**PLANNING DIVISION REPORT
DEPARTMENT OF PLANNING AND COMMUNITY
AND ECONOMIC DEVELOPMENT
March 10, 2008**

RE: LD. # 09434, Conditional Use Application – 89 East Towne Mall

DATE: February 1, 2008
TO: Plan Commission
FROM: Larry D. Nelson, P.E., City Engineer
SUBJECT: *for* 89 East Towne Mall Conditional Use

REPORT OF: URBAN DESIGN COMMISSION**PRESENTED:** February 27, 2008**TITLE:** 89 East Towne Mall – New Building
Addition to a Planned Commercial Site for
Buffalo Wild Wings. 17th Ald. Dist.
(08547)**REFERRED:****REREFERRED:****REPORTED BACK:****AUTHOR:** Alan J. Martin, Secretary**ADOPTED:****POF:****DATED:** February 27, 2008**ID NUMBER:**

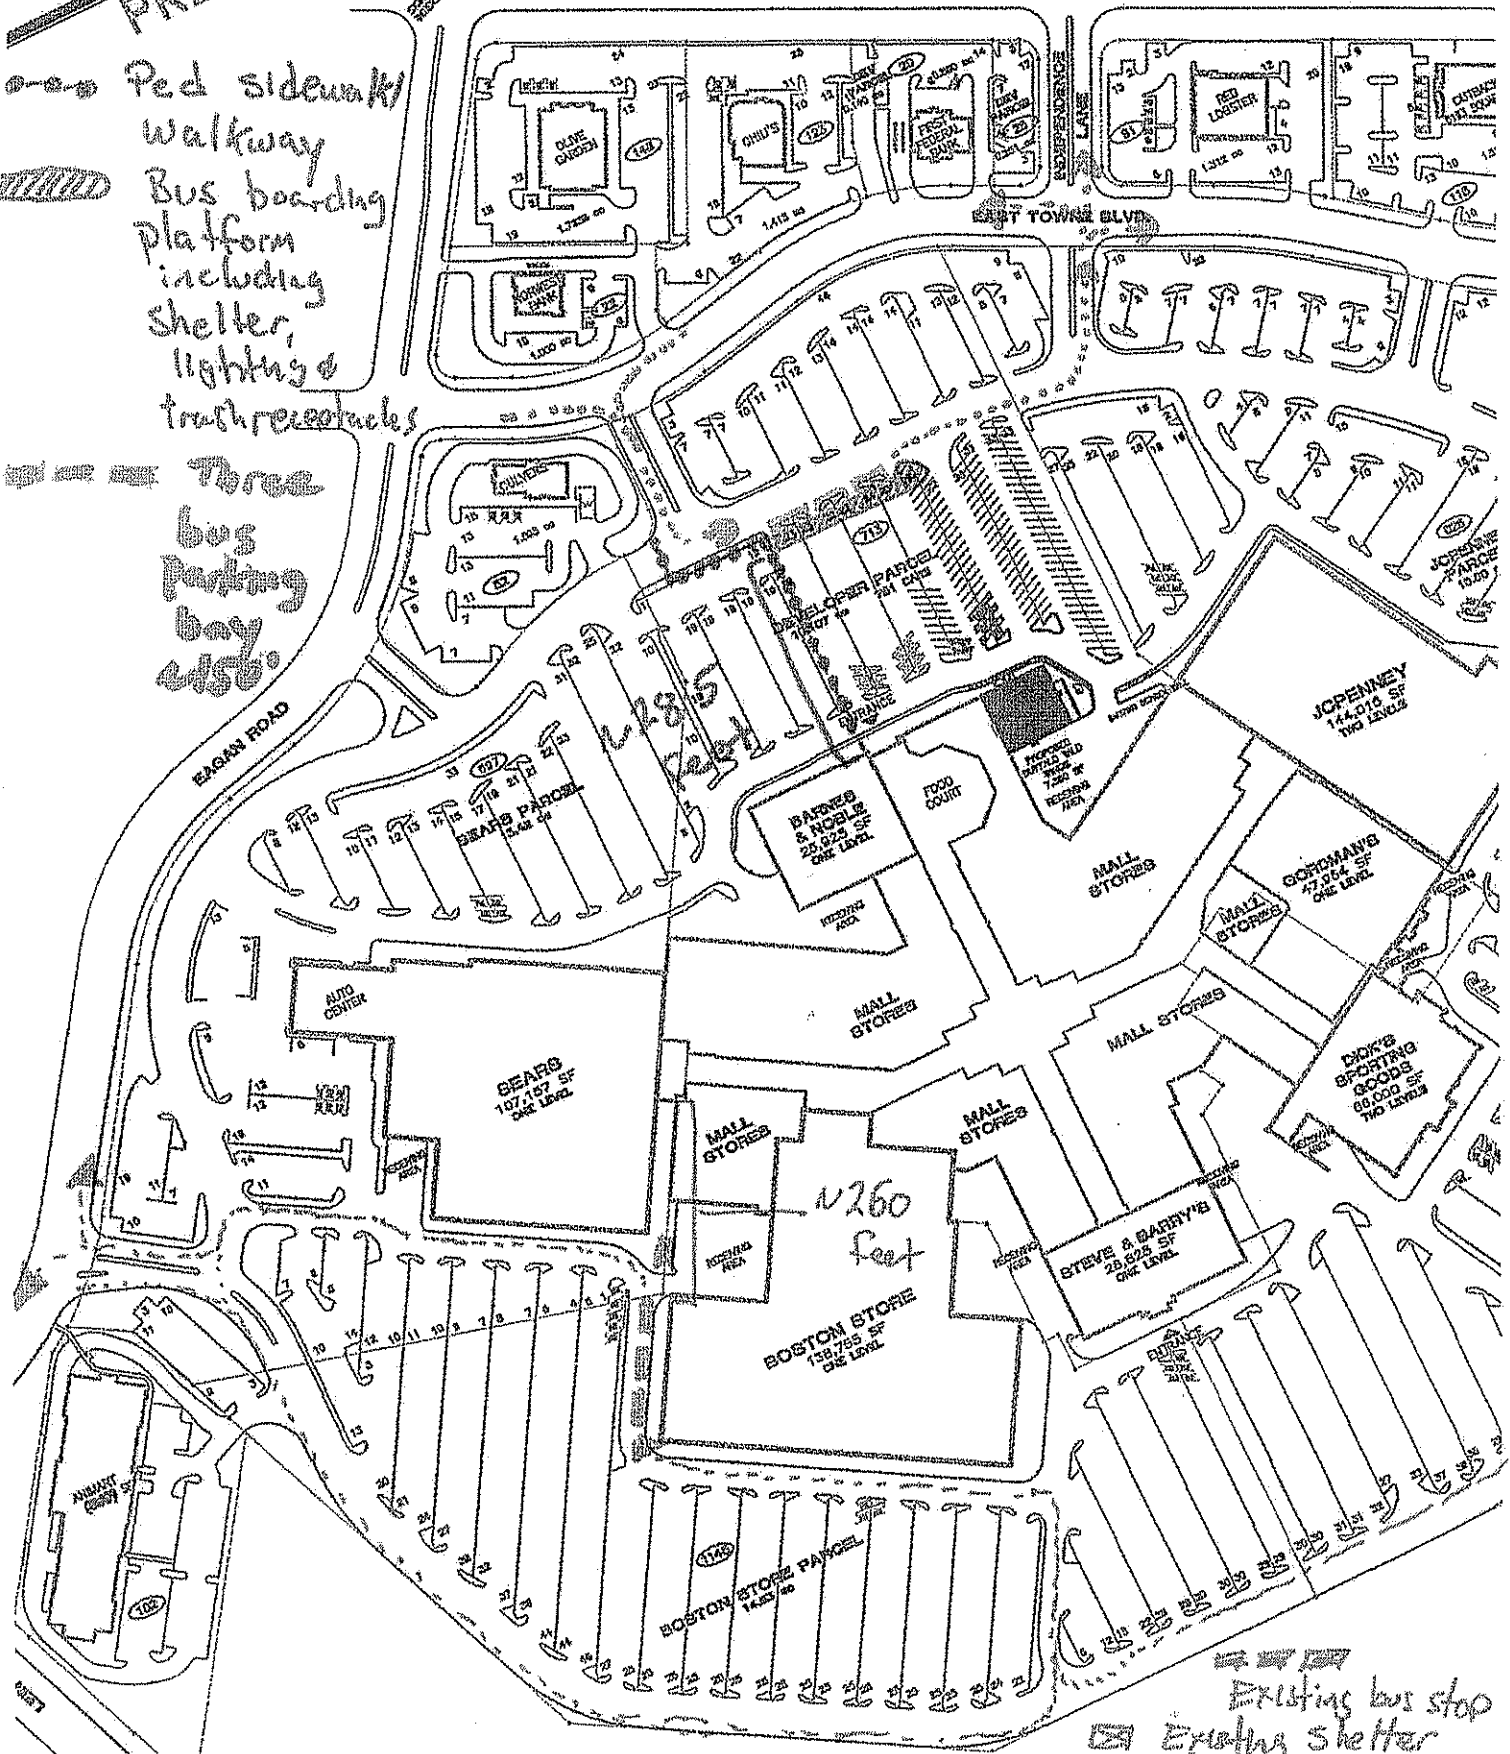
Three
bus
parking
bay
also.

Existing bus stop
Existing shelter
